OIL - REPLACE THE FUEL COOLED OIL COOLER ATTACHING BOLTS - CATEGORY CODE 4 -
MOD.ENG-79-0019

V2500-ENG-79-0019

Fuel Cooled Oil Cooler
Fig.1

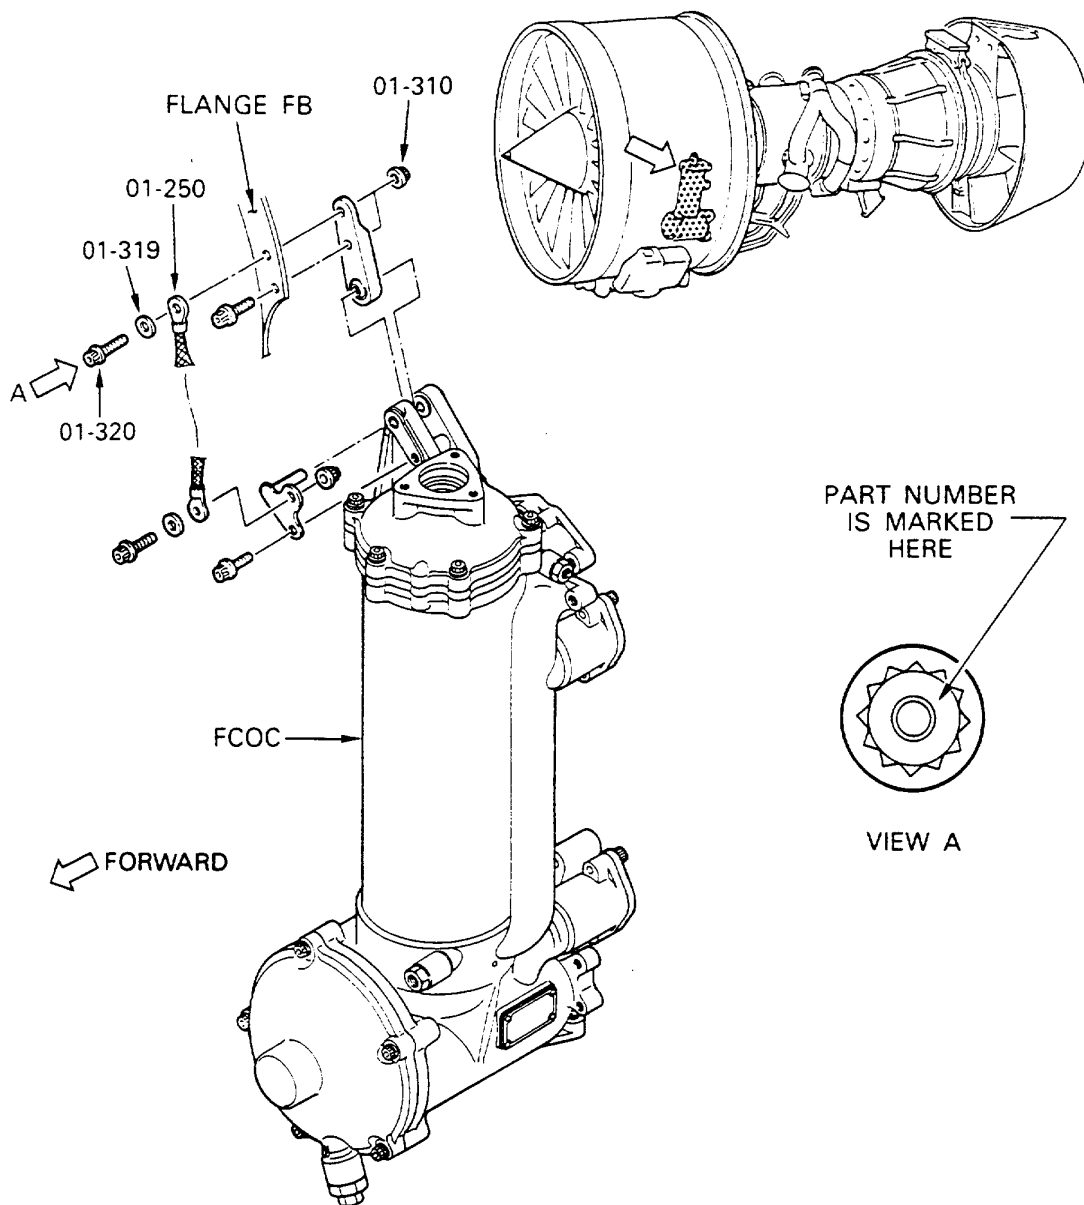
- (1) Remove the two bolts (79-21-43, 01-320). Refer to Figure 1.
- (2) Replace the AS21514 Bolt with the AS22514 Bolt.

- (1) Install the AS22514 Bolt and torque the nut (79-21-43, 01-310) to between 85 and 95 lbfin (0,96 and 1,07 mdaN).
